**CITY OF SEATTLE  
ANALYSIS AND DECISION OF THE DIRECTOR OF  
THE DEPARTMENT OF PLANNING AND DEVELOPMENT**

**Application Number:** 2306110  
**Applicant Name:** Security Properties  
**Address of Proposal:** 5700 24th Avenue NW

**SUMMARY OF PROPOSED ACTION**

Canopy at Southwest Corner

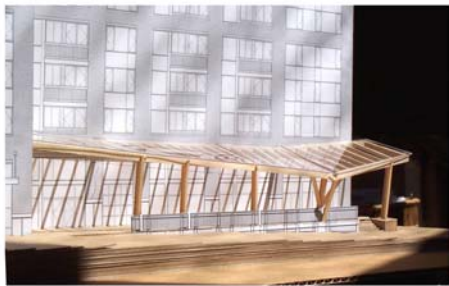
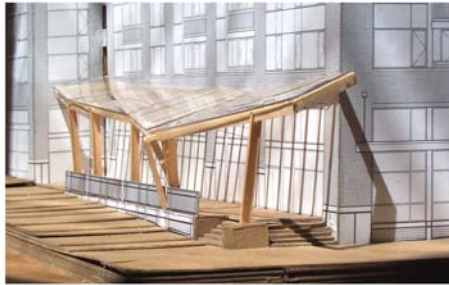
The Board determined that the artistic canopy along the west façade is a desirable feature. They particularly liked the use of rainwater shed by it as a feature at the pedestrian level.

The Board recommends a condition that the feature needs to be a bolder, larger gesture than the modeled version shown. It should also provide overhead weather protection for public sidewalk pedestrians to the greatest extent possible while still incorporating the rainwater features.
